RE: Building & Grounds Activity

Roof Condition Evaluation

Fire Station #2
Village of Barrington Hills
120 S. Algonquin Road
Barrington Hills, IL 60010

PROJECT: Village of Barrington Hills Fire Station #2			JOB NO.: 14001
ROOF AREA: North Roof	ROOF AGE: 20 years	BLDG TYPE: Masonry	ROOF SLOPE: 5:12
EVALUATION BY: Robert Heideman and William Richardson on April 11, 2014

DRAWING TITLE:
ROOF SKETCH

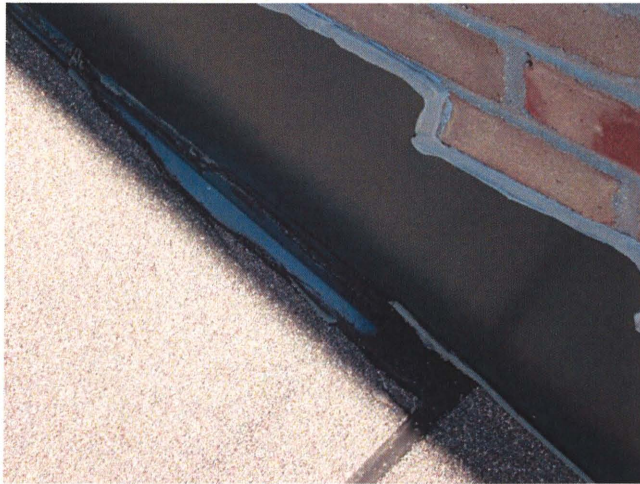
1. Replace split shingles (Photos #7 & 9)
2. Replace deteriorated ridge caps (Photo #8)
3. Re-nail fastener, seal shingle (Photo #10)
4. Remove shingles, re-nail plywood, install new shingles (Photo #12)

1. Repair open seams on low slope valley east side (Photos #2 & 4)
2. Remove backed out fastener, install new fastener (Photo #3)

2. OPEN FLASHING

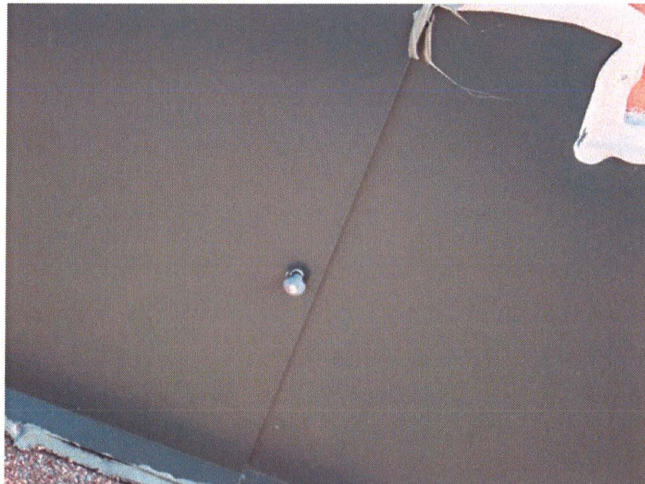
Low slope valley on east side has open seams at wall and ridge, heat cables detached
